CODE COMPLIANCE CERTIFICATE

Consent No: 100637

Building Work			
Building Consent No:	100637	Issued by:	Kāpiti Coast District Council
Project Description:	Stage 1 of 2; build implement shed with bedroom/ensuite, and a separate studio/kitchen with living accommodation including bedroom, bathroom.

STAGE ONE: BEDROOM-STUDIO IMPLEMENT SHED- WORKSHOP FOR PAETAUA TRUST

IMPLEMENT SHED — WORKSHOP

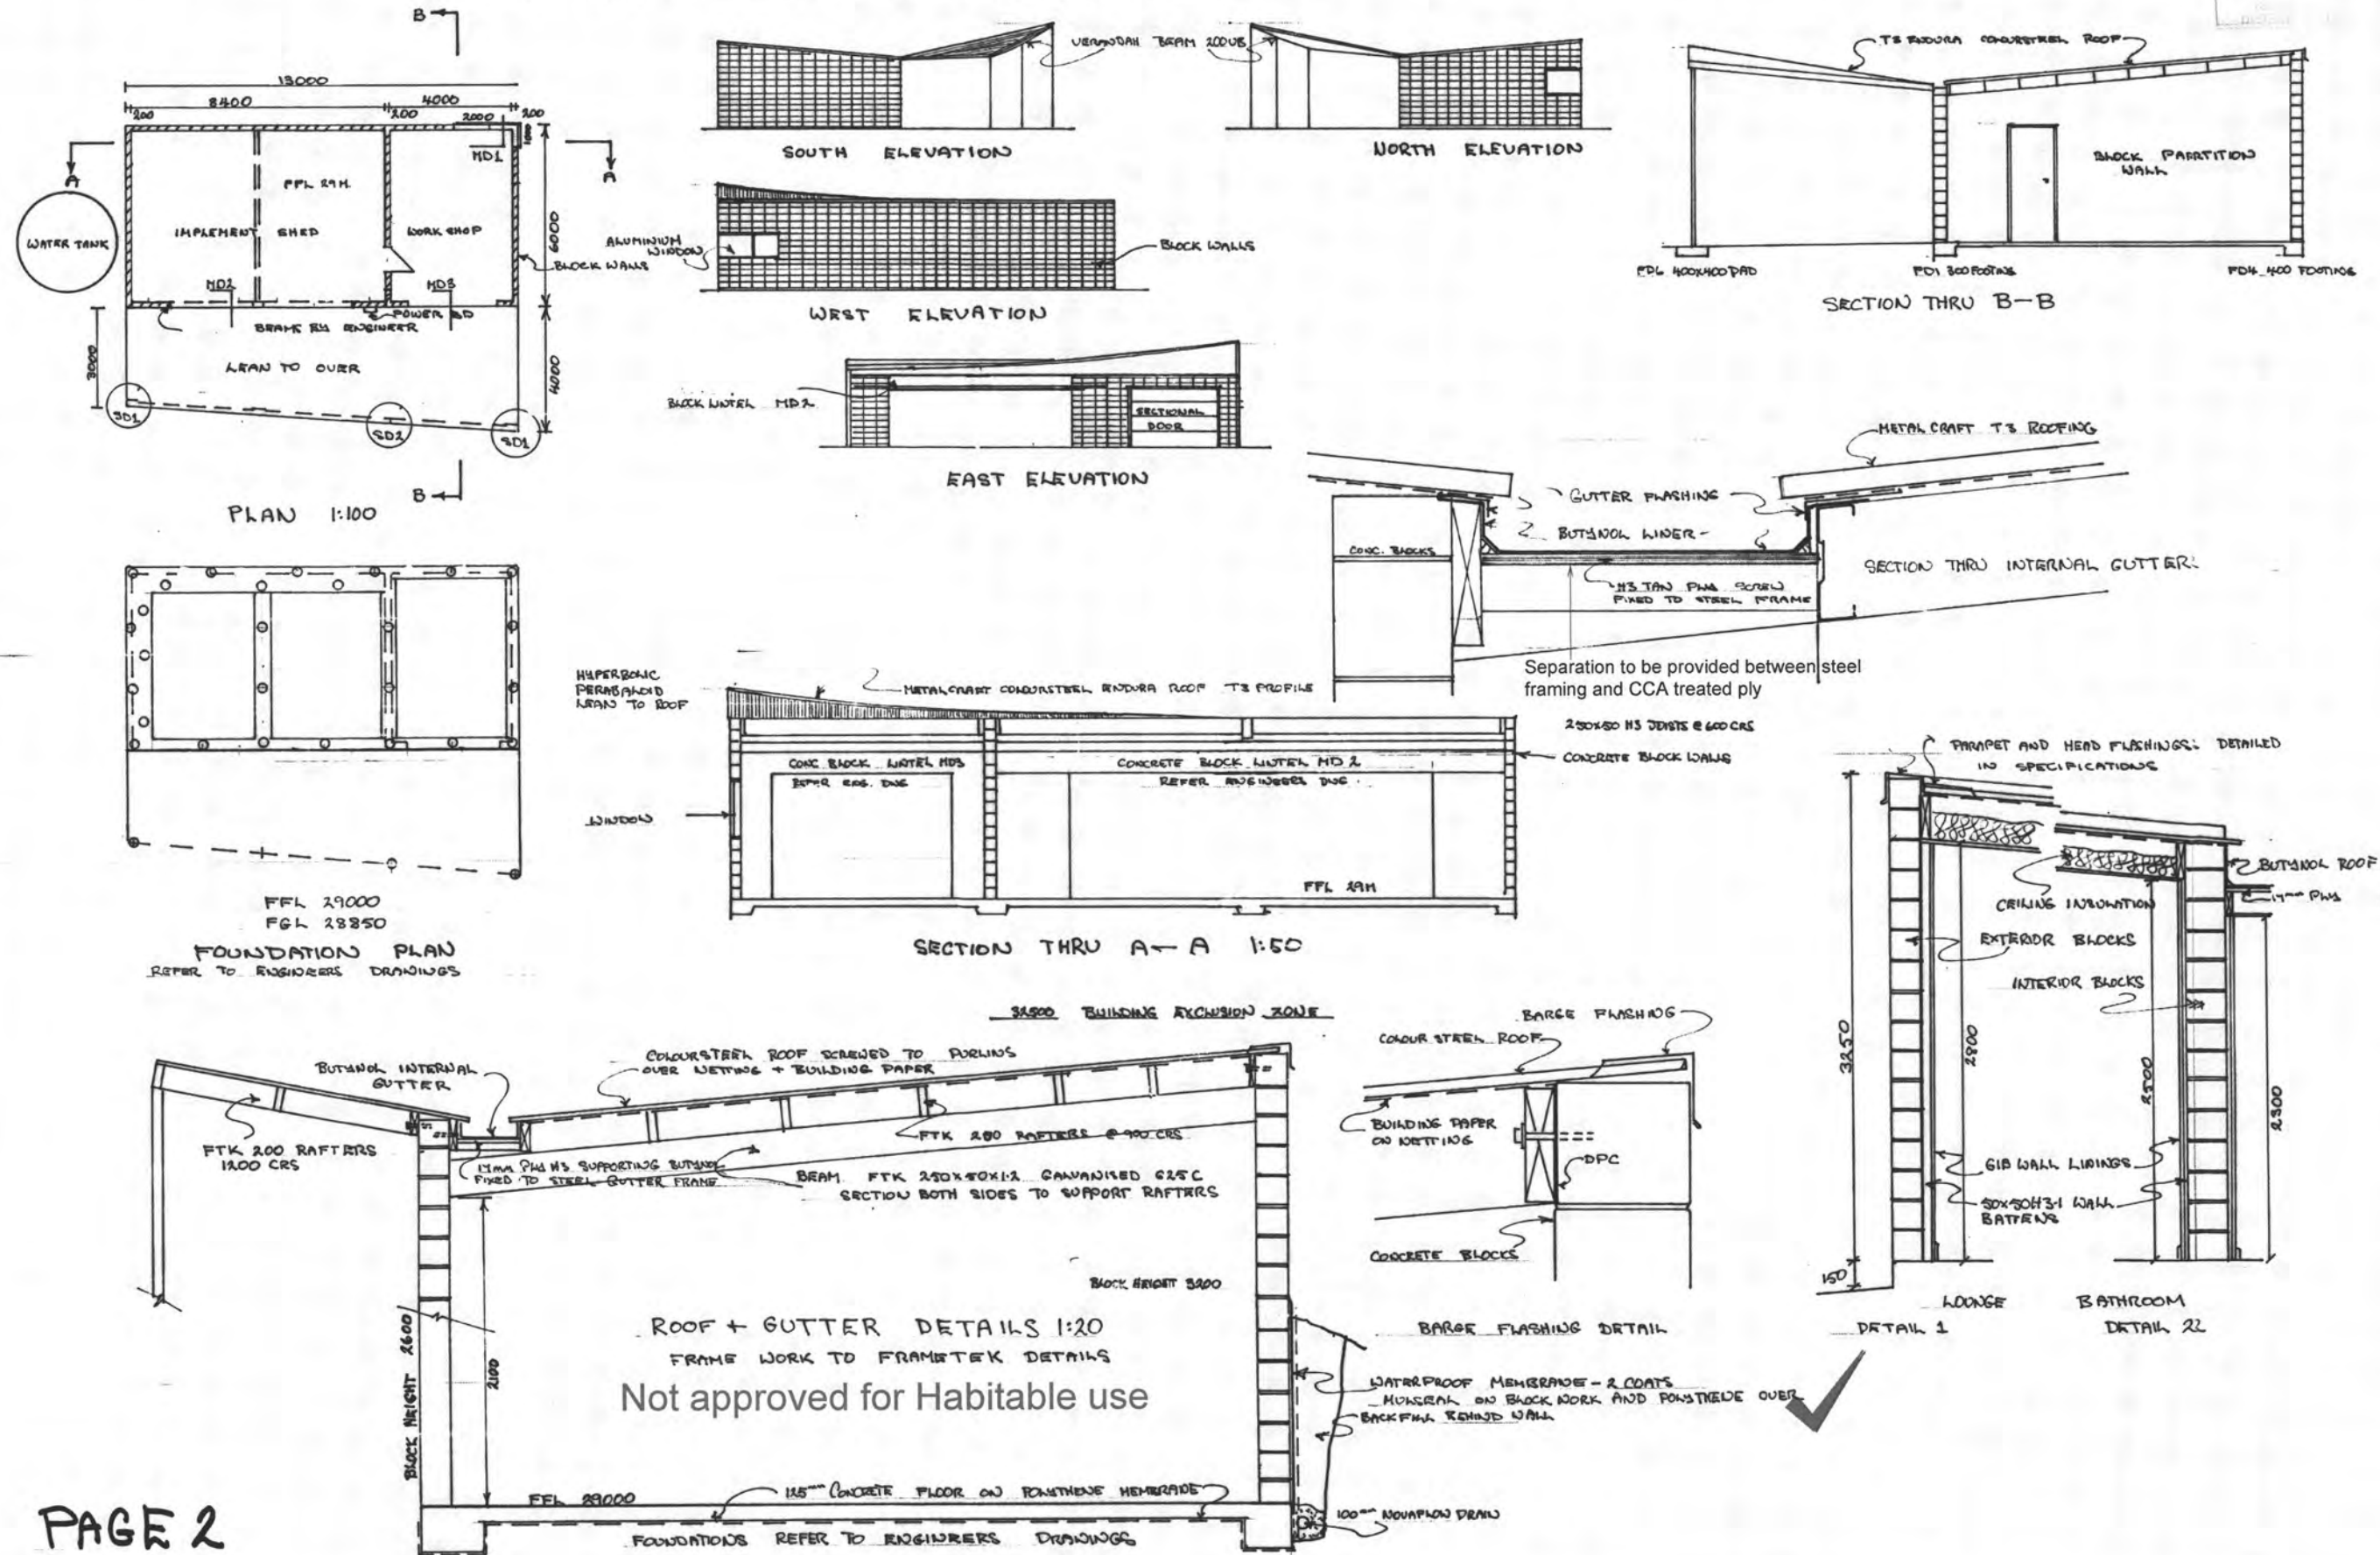
preline plumbing inspection required.

frost prone water pipes are to be lagged with a suitable type of insulation.

gas fitter to provide a compliance certificate to council

Provide electrical certification after completion and prior to Code Compliance Certificate being issued

TYPICAL EXTERIOR WALL DETAIL
SHOWING STRAPPING TO BLOCKWORK
AND POLYSTYRENE INSULATION

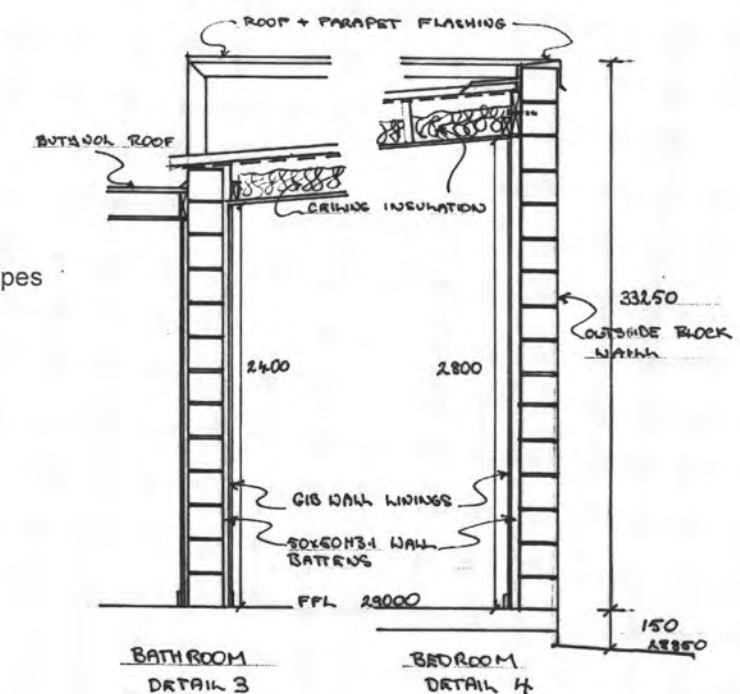
Some secondary water treatment may be required

Important-
Ensure compatibility of services (pipes
and electrical cabling) in contact
with polystyrene to prevent PVC
migration

Check the potability of the water supply on a regular basis.

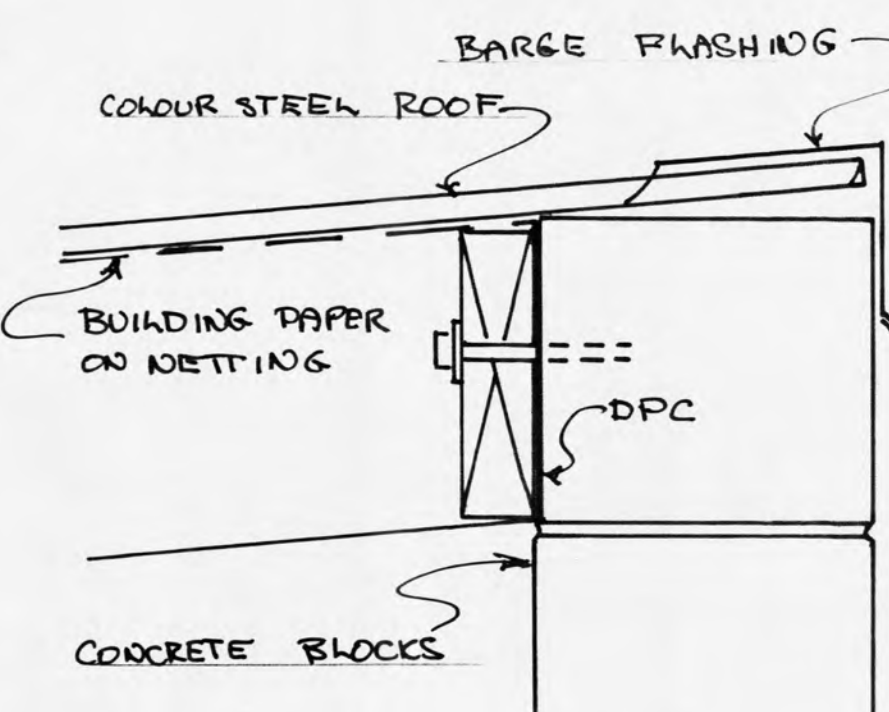
Not approved for Habitable use

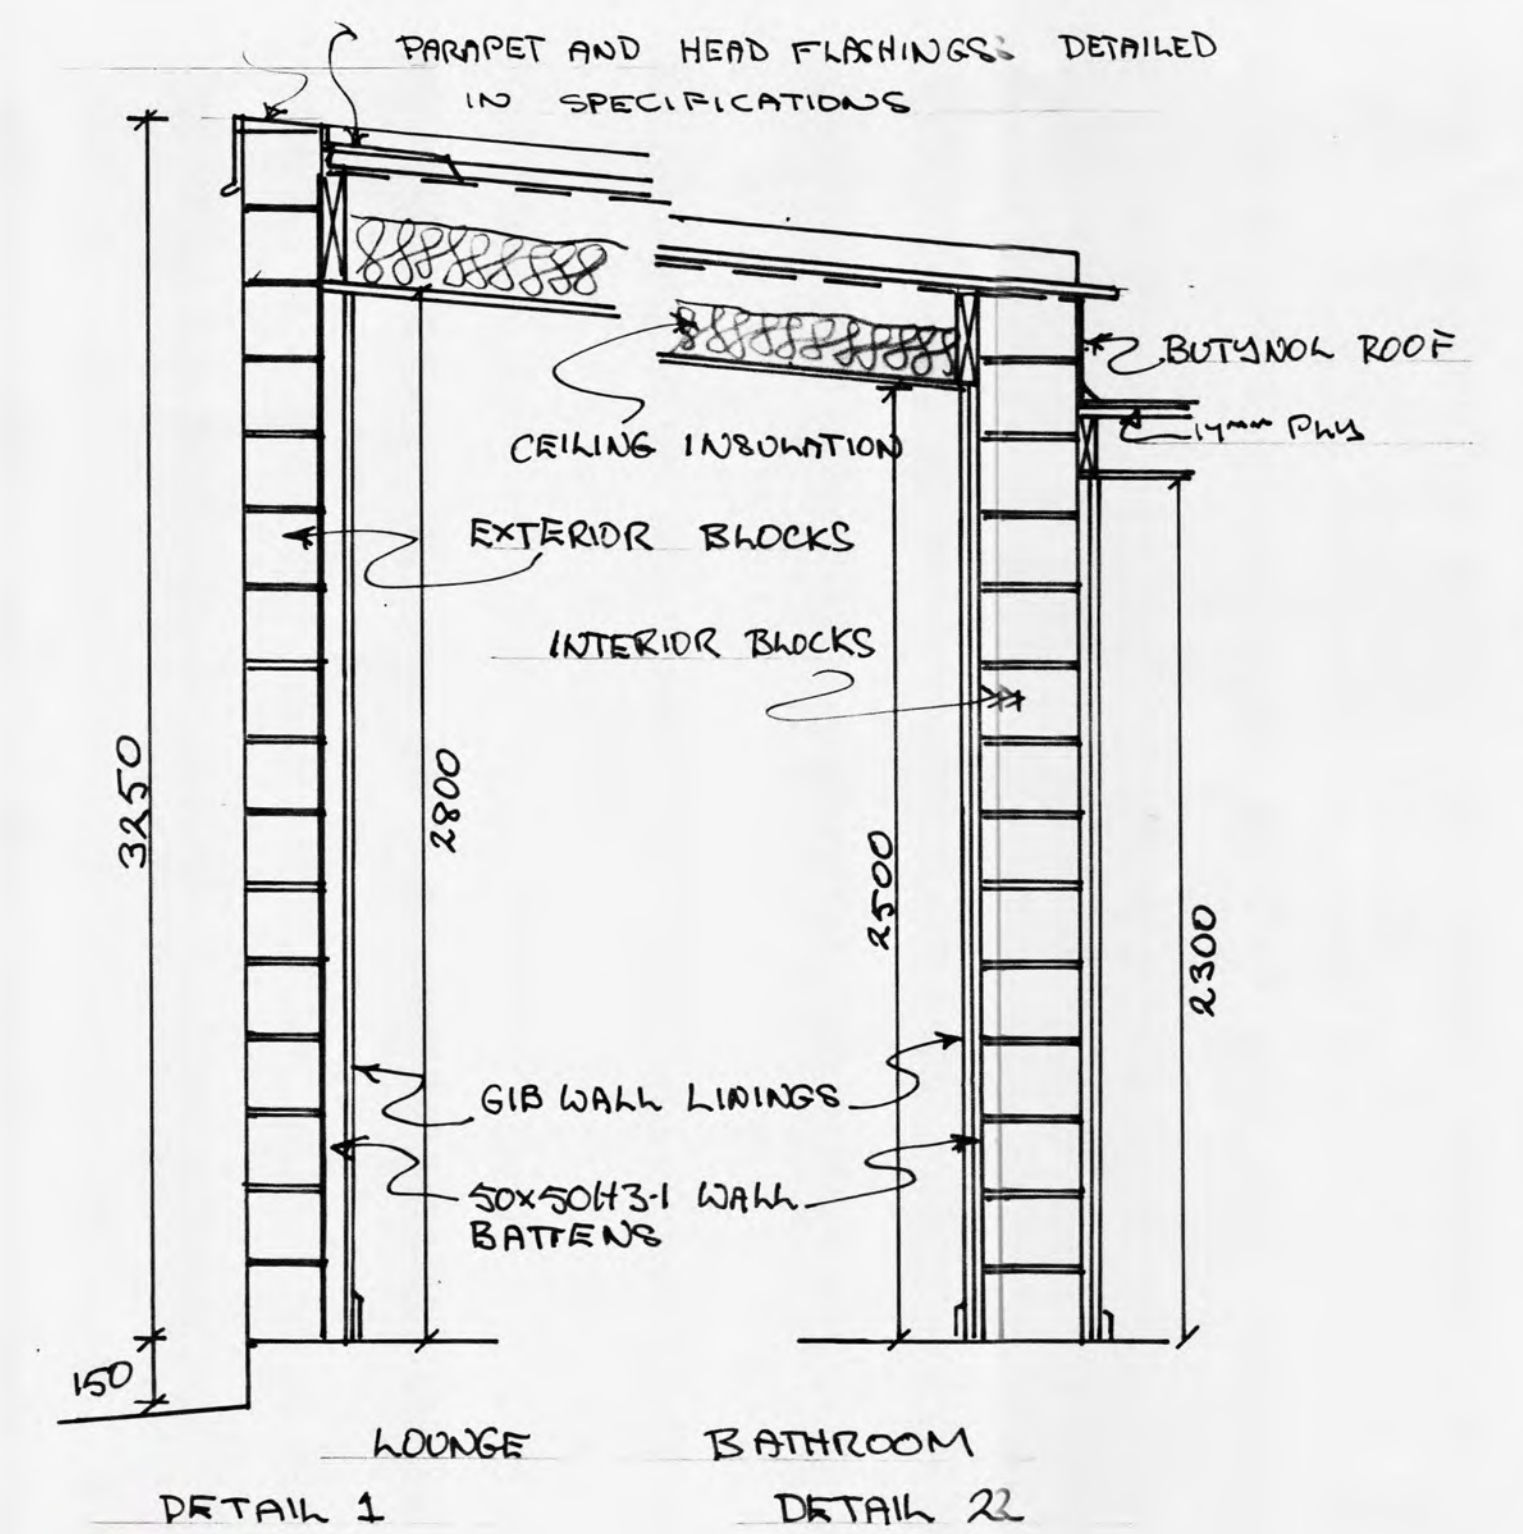
preline plumbing inspection required.

frost prone water pipes are to be lagged with a suitable type of insulation.

Provide electrical certification after completion and prior to Code Compliance Certificate being issued

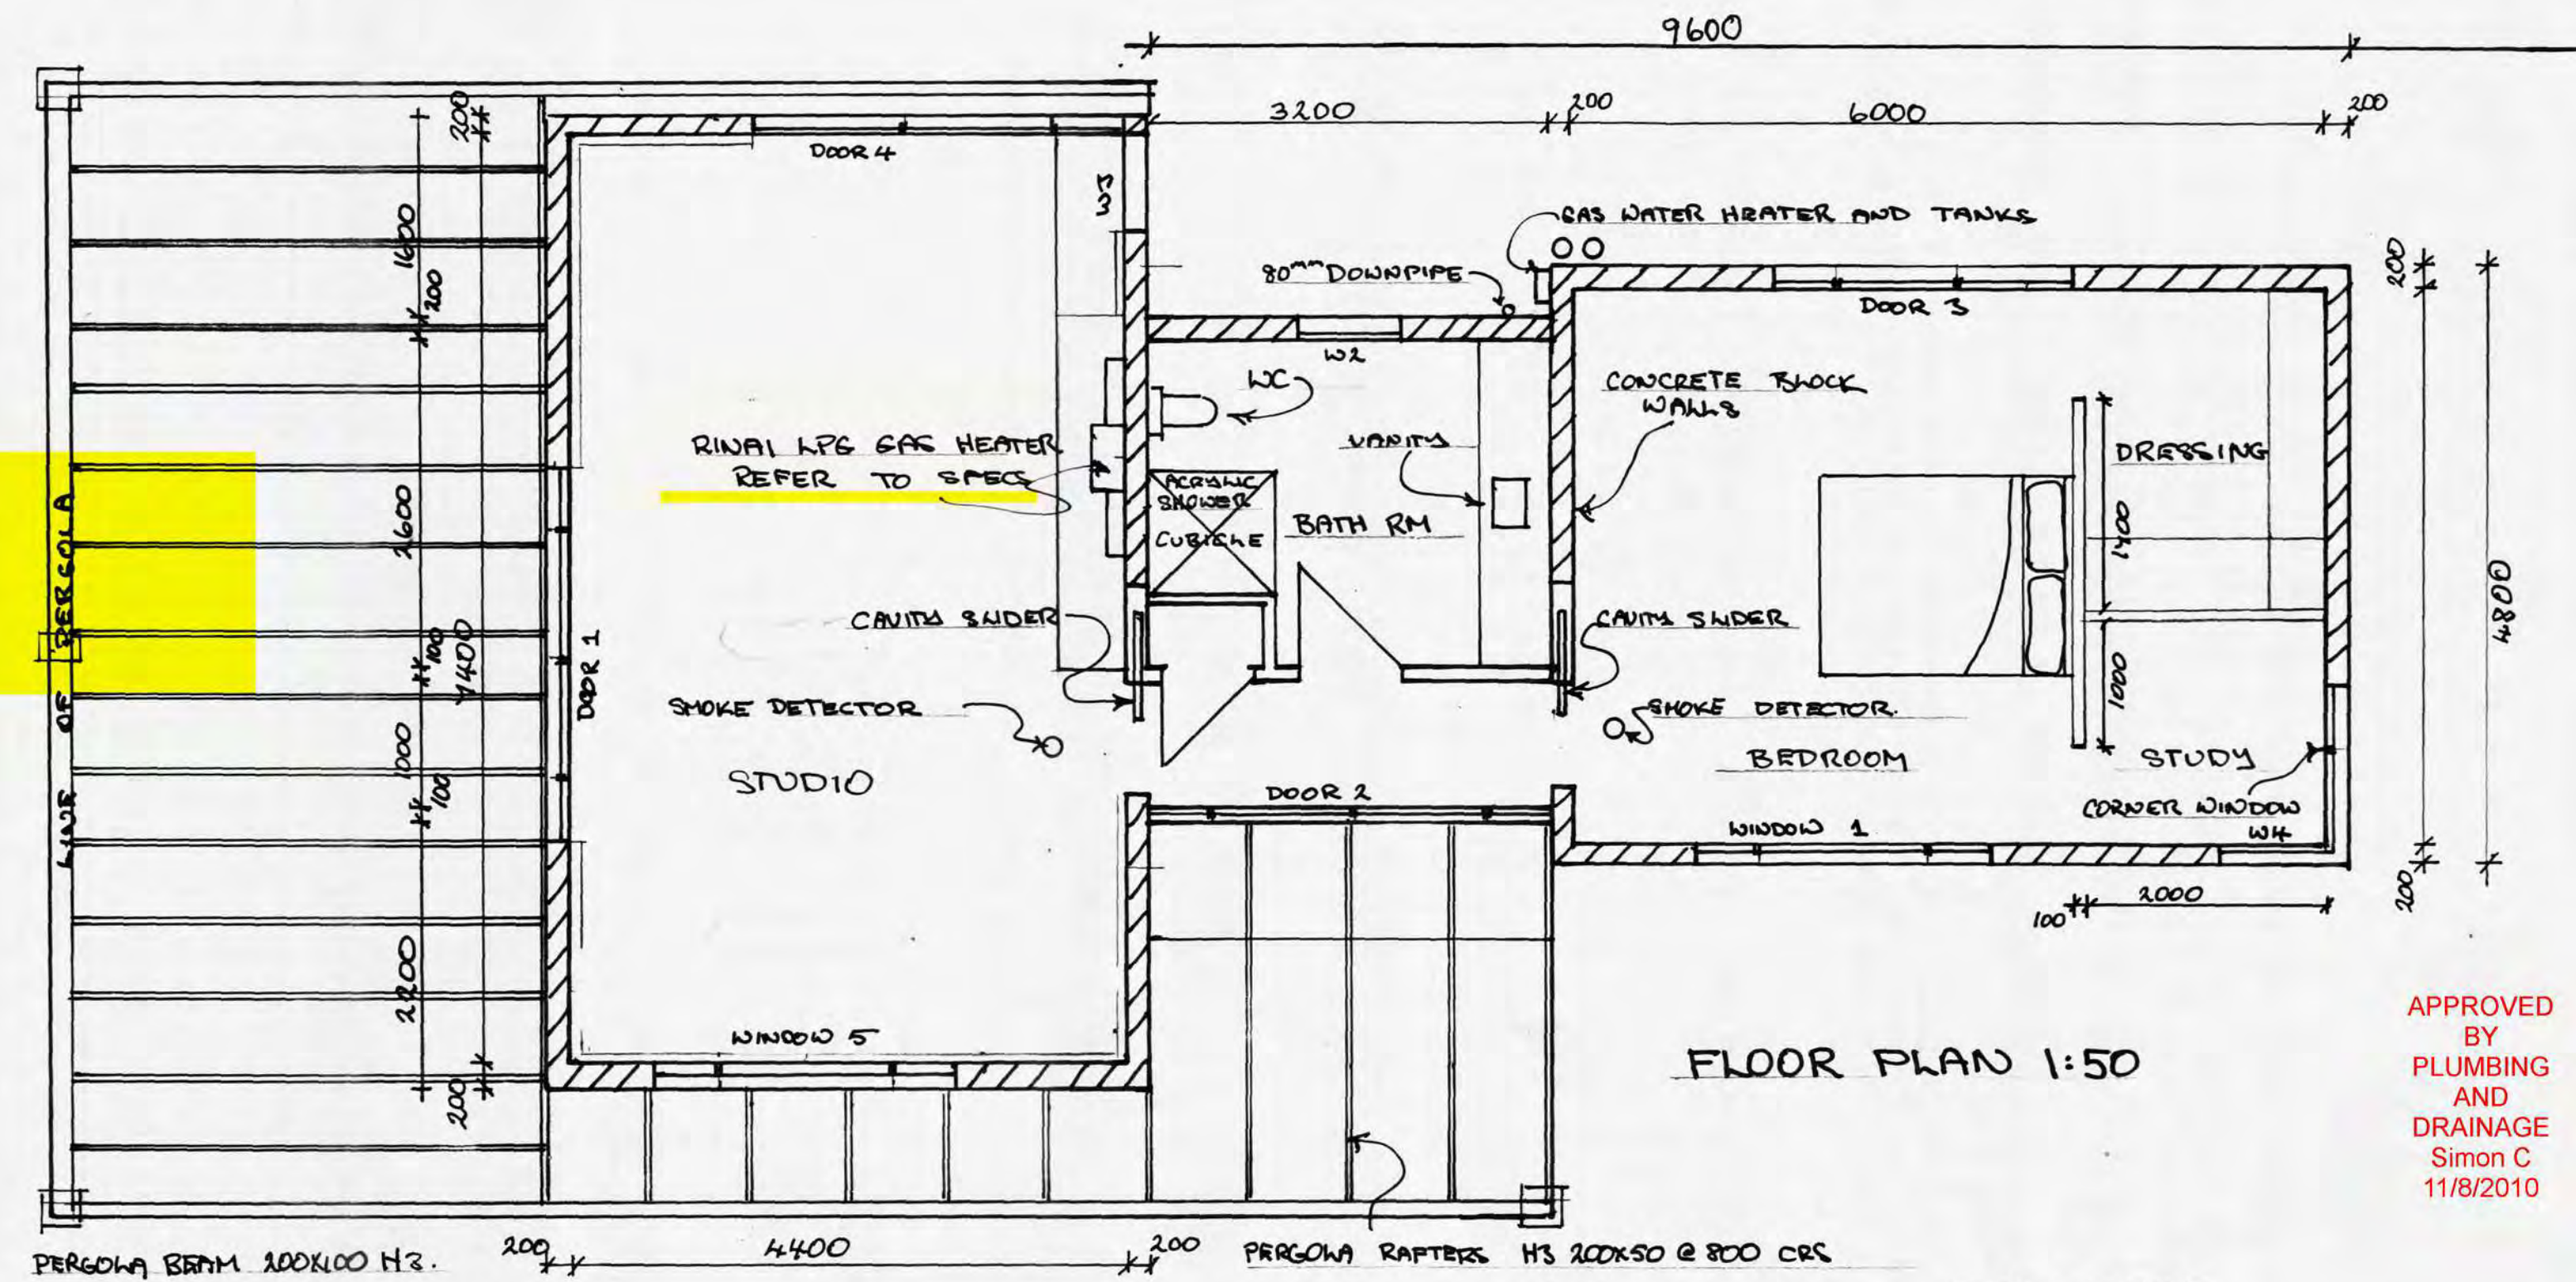
Pergola not part of consent at applicant's request.
